**City of Lake Elmo Planning Commission
Meeting City Council Chambers – 3880 Laverne
Avenue North Minutes of Regular Meeting of
May 12th, 2025**

TO: Planning Commission
FROM: Sophia Jensen, Senior City Planner
AGENDA ITEM: **Berschens Shores 3rd Addition Minor Subdivision and Zoning Map Amendment**
REVIEWED BY: Ashley Monterusso, City Planner

TO: Planning Commission
FROM: Ashley Monterusso, City Planner
AGENDA ITEM: **Primrose Daycare Conditional Use Permit**
REVIEWED BY: Sophia Jensen, Senior City Planner
Jason Stopa, CD Director

To: Sophia Jensen, Senior City Planner
Jason Stopa, Community Development Director
Marty Powers, Public Works Director
Nate Stanley, City Engineer
Chad Isakson, Assistant City Engineer
From: Jack Griffin, Sr. Project Manager
Re: Primrose School CUP

SITE PLAN

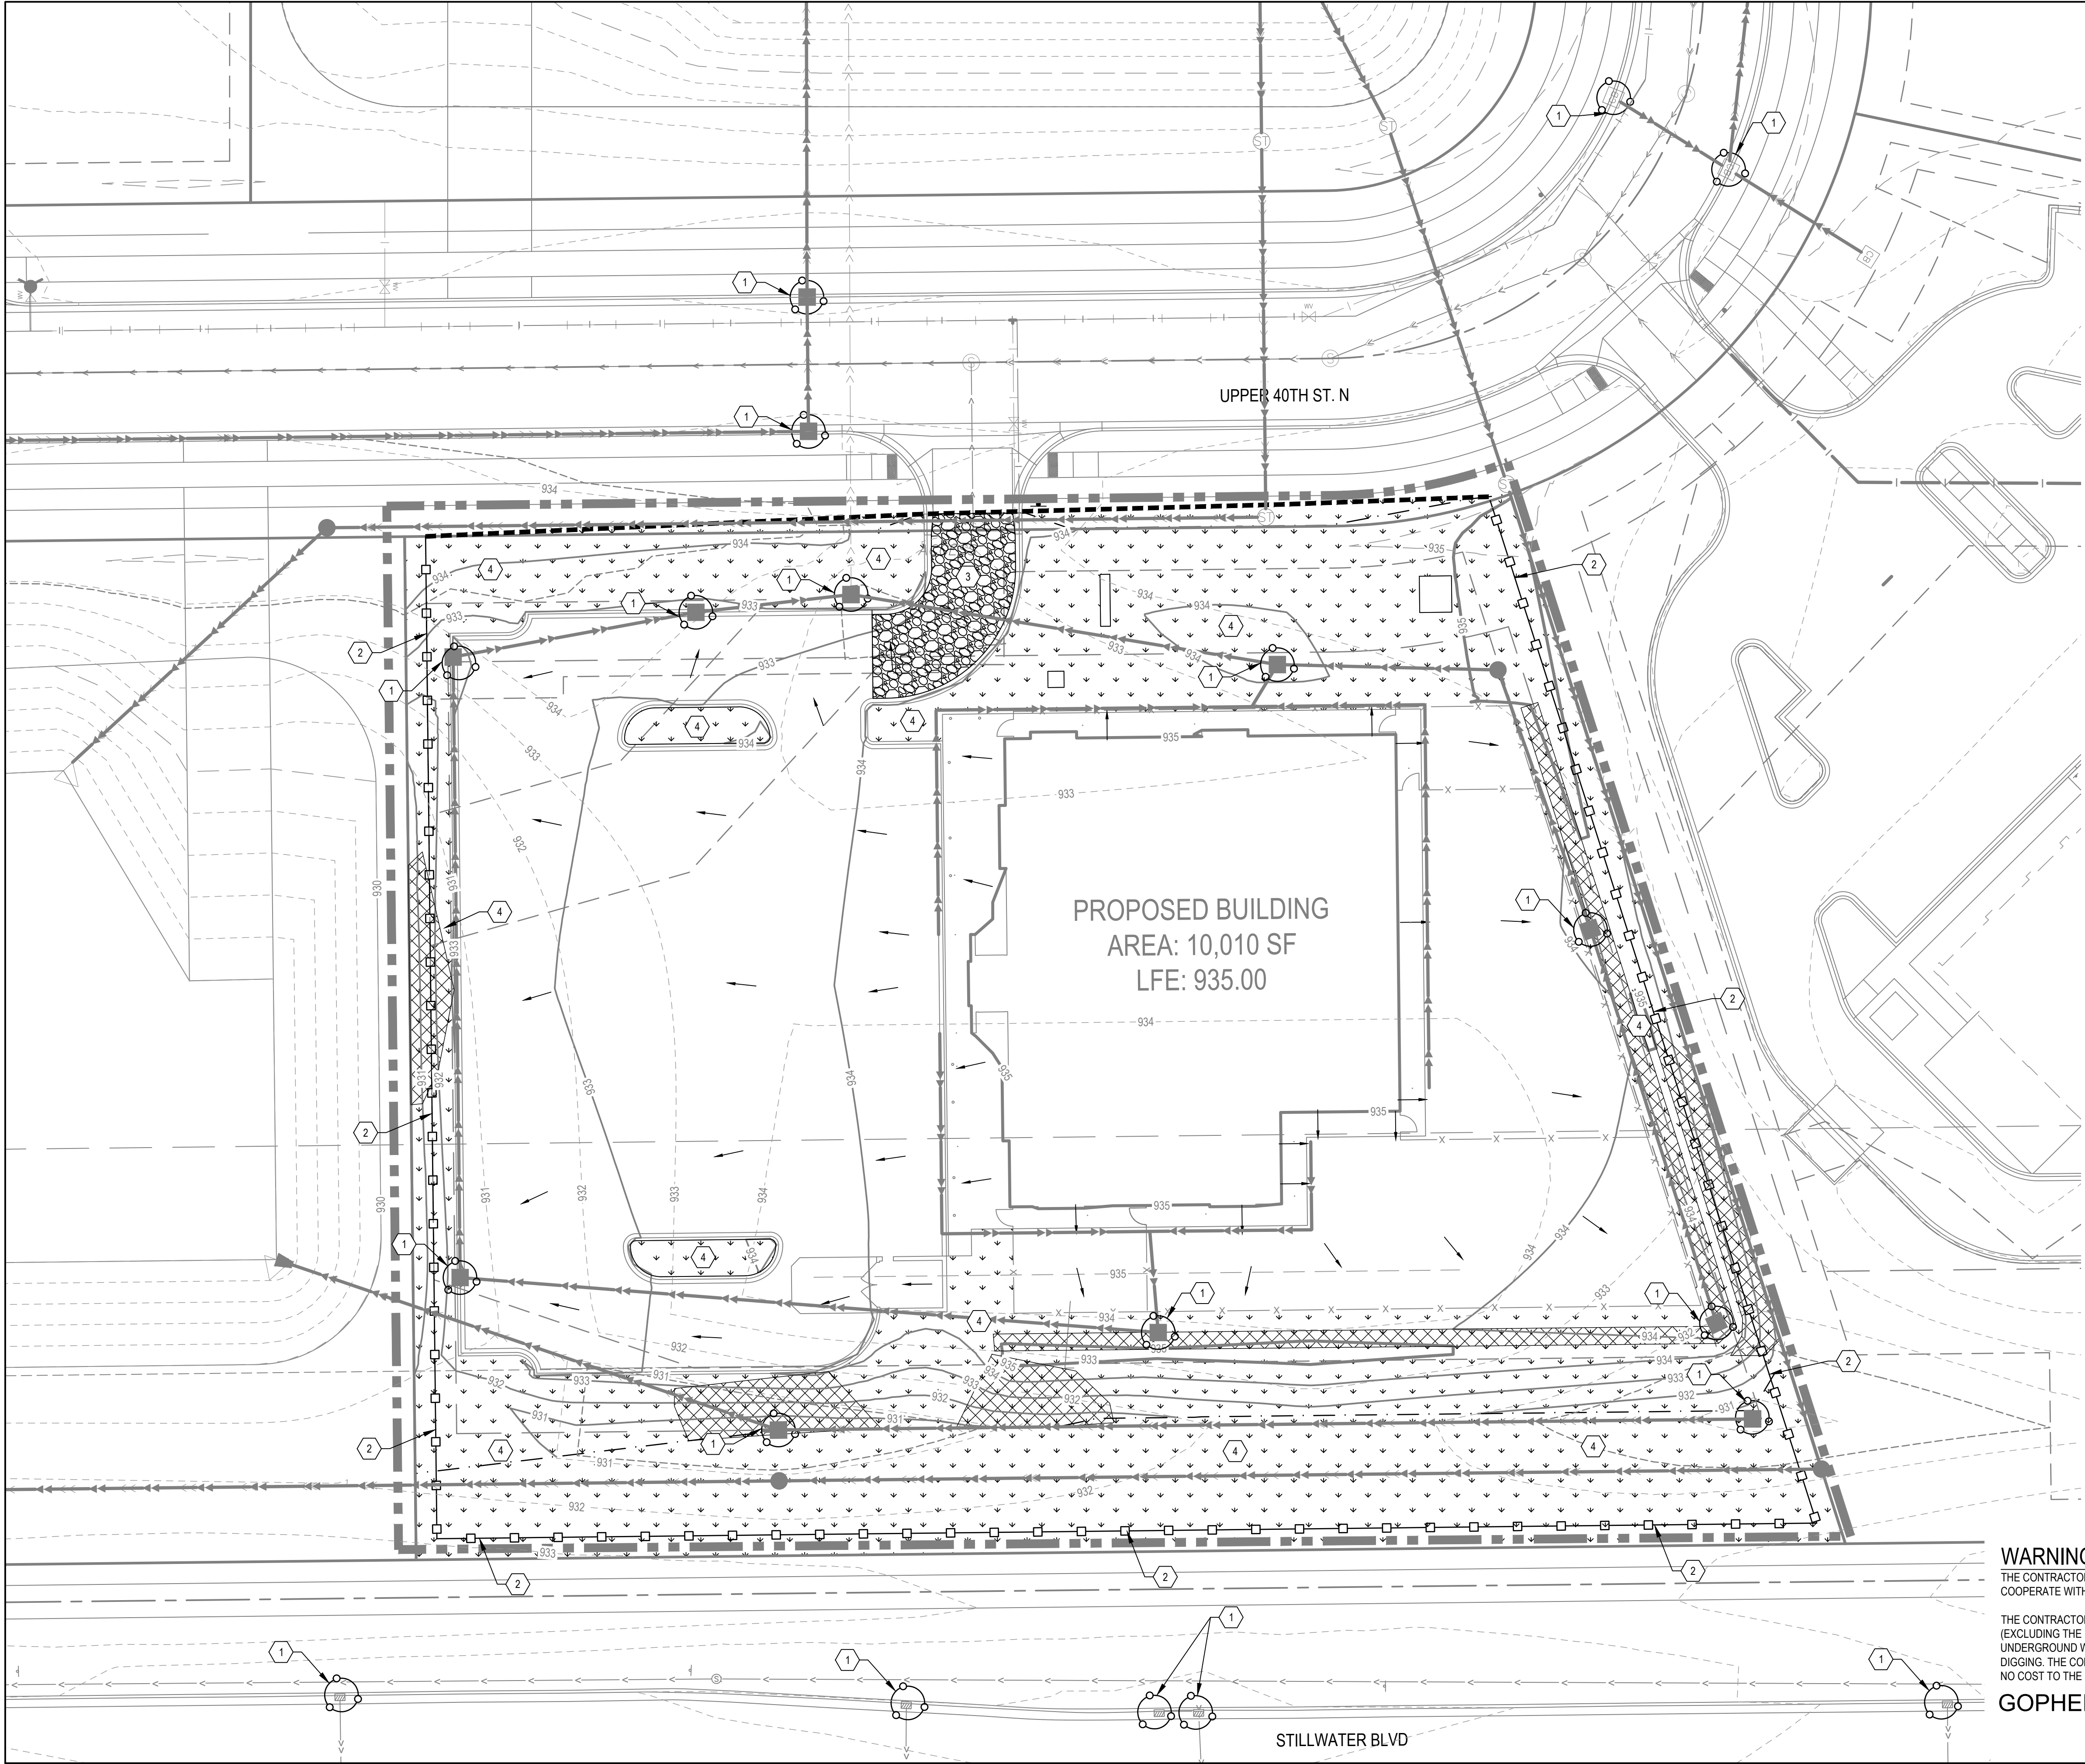
6. C-101. The commercial driveway access location is shown as approved in the Bridgewater Subdivision Improvements.
7. C-301. Site grading will be required to maintain the drainage plan as approved by the VBWD and City for the Bridgewater Subdivision Improvements, including key emergency overflow elevations and flow paths. All emergency overflow elevations must be shown and labeled on the plans.

UTILITY PLAN

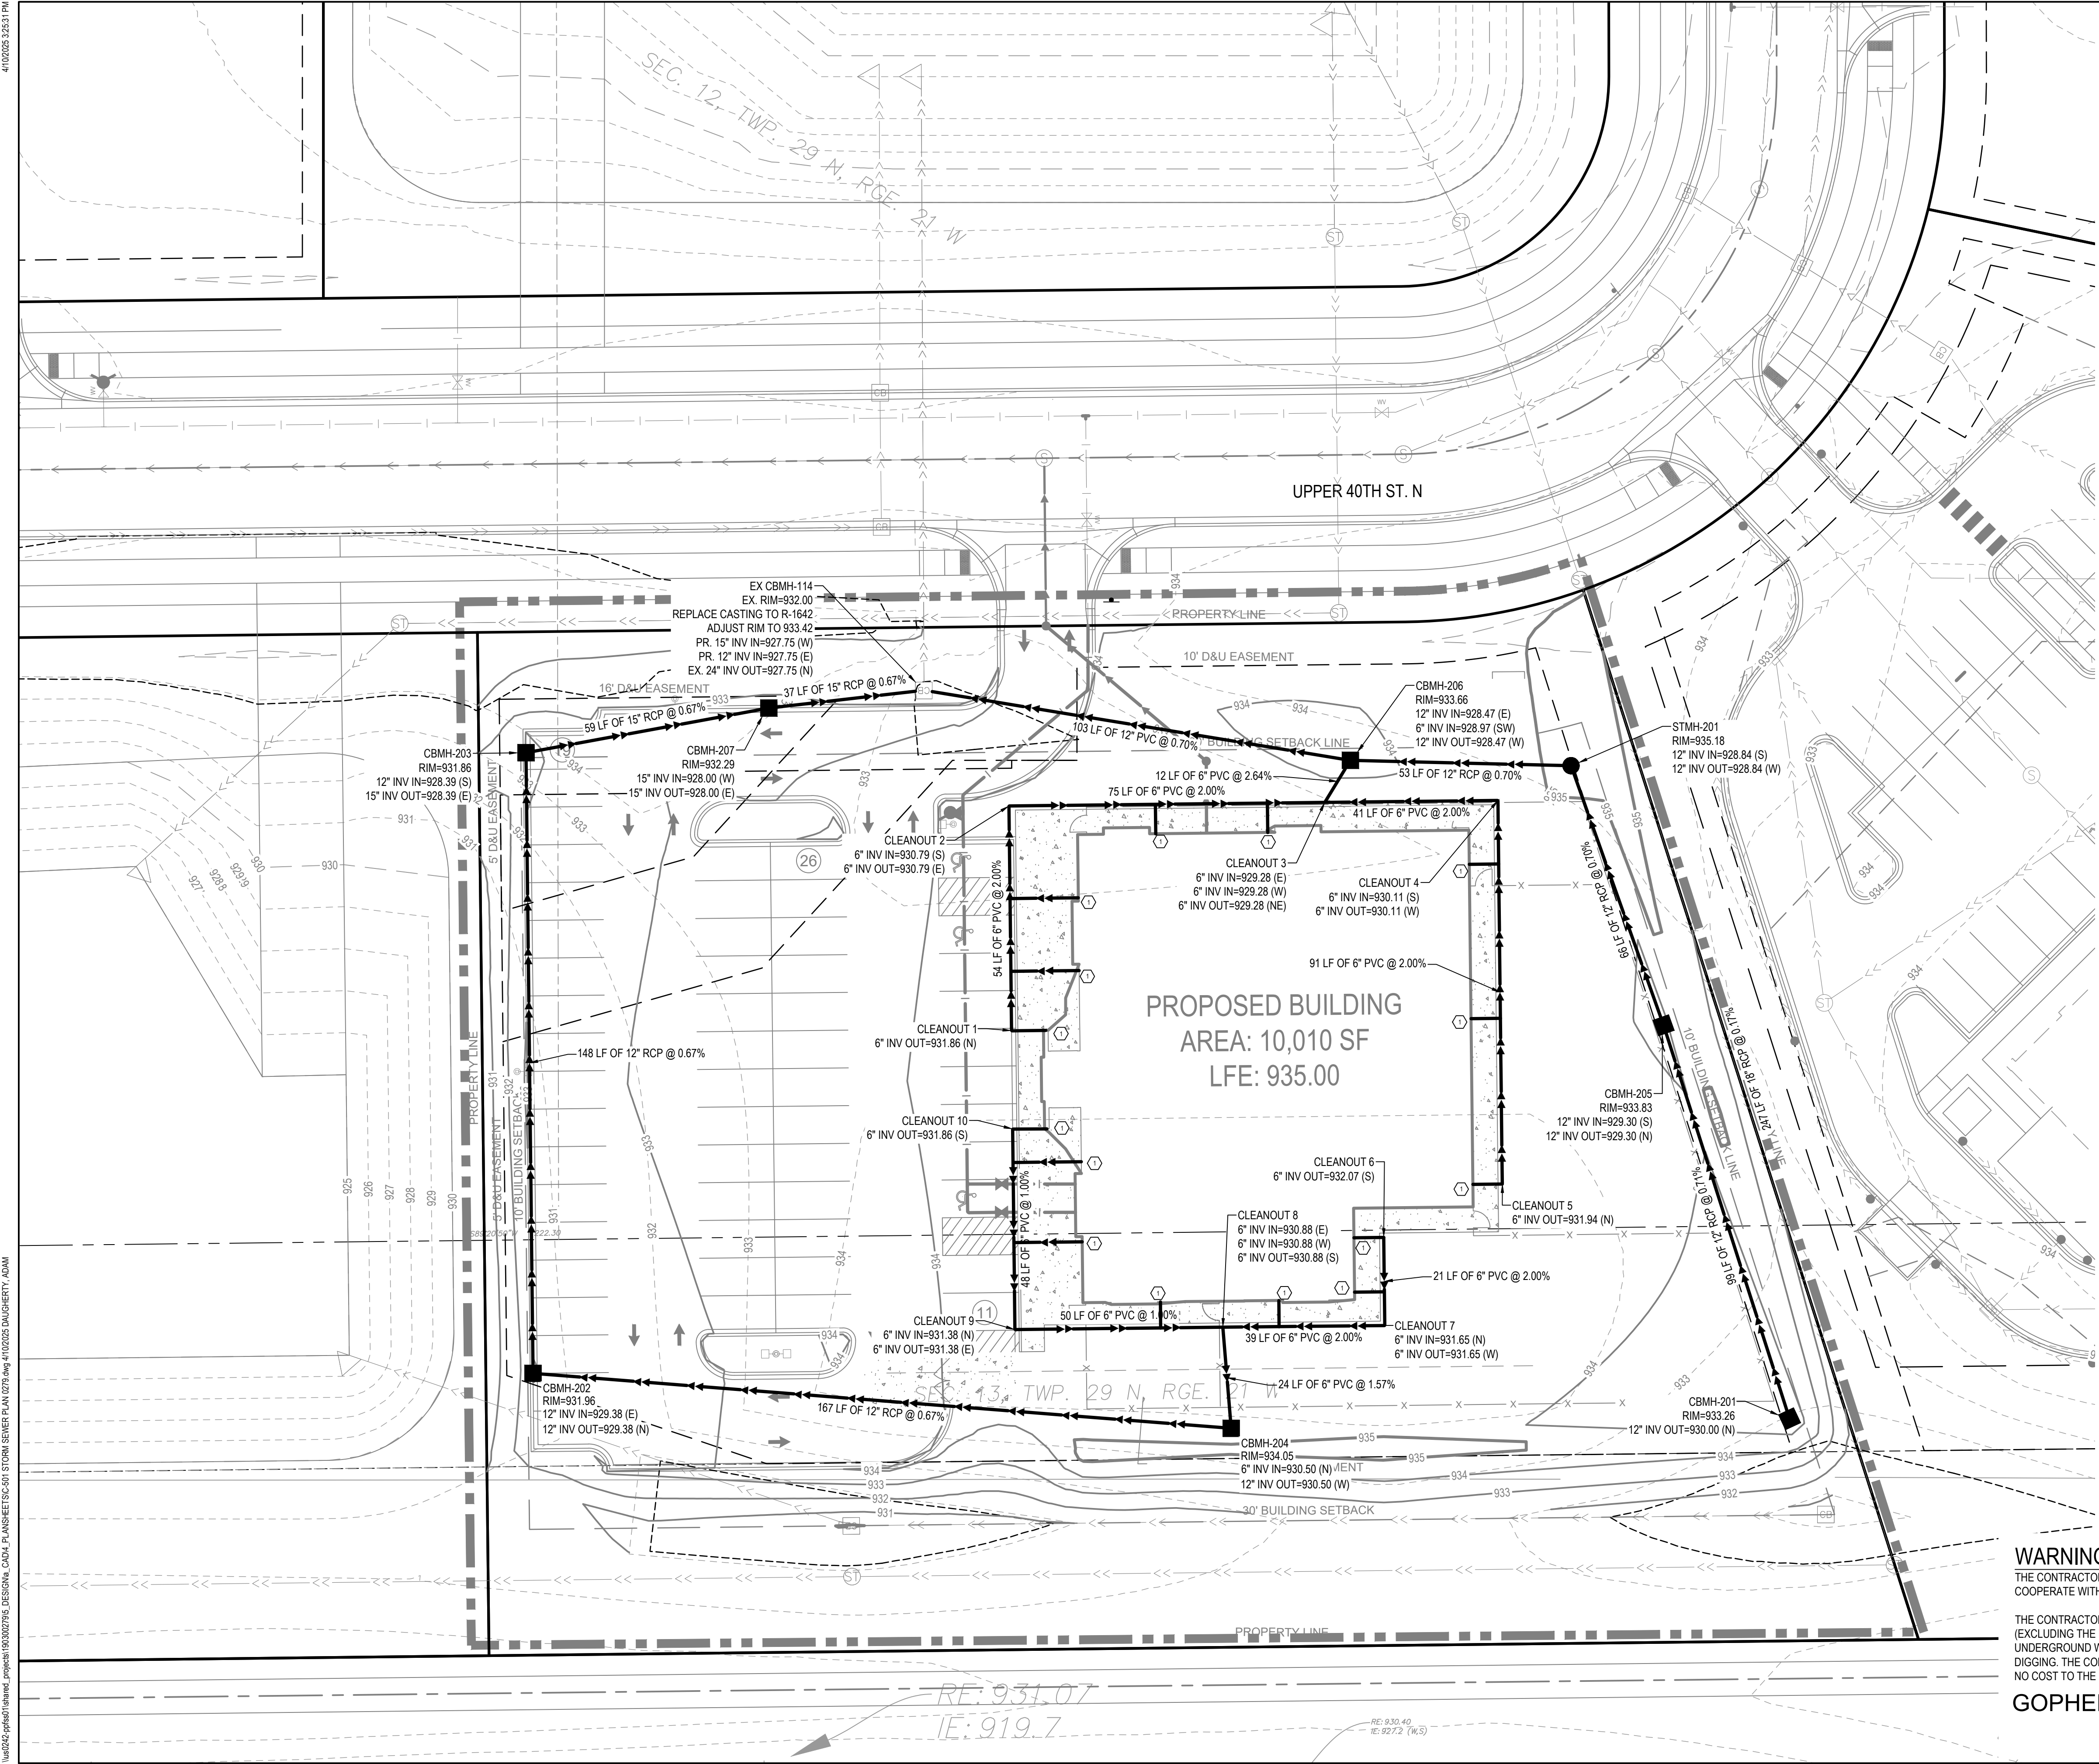
8. C-401. The proposed hydrant location must be reviewed and approved by the Lake Elmo Fire Department. Additional utility easements are needed to provide a minimum 30-ft wide easement over all public owned watermain and hydrants.

9. C-401. A 6-inch gate valve must be placed immediately after the hydrant location, at the start of the private water service line. The plans must be revised to label the public owned watermain and the private water service line.
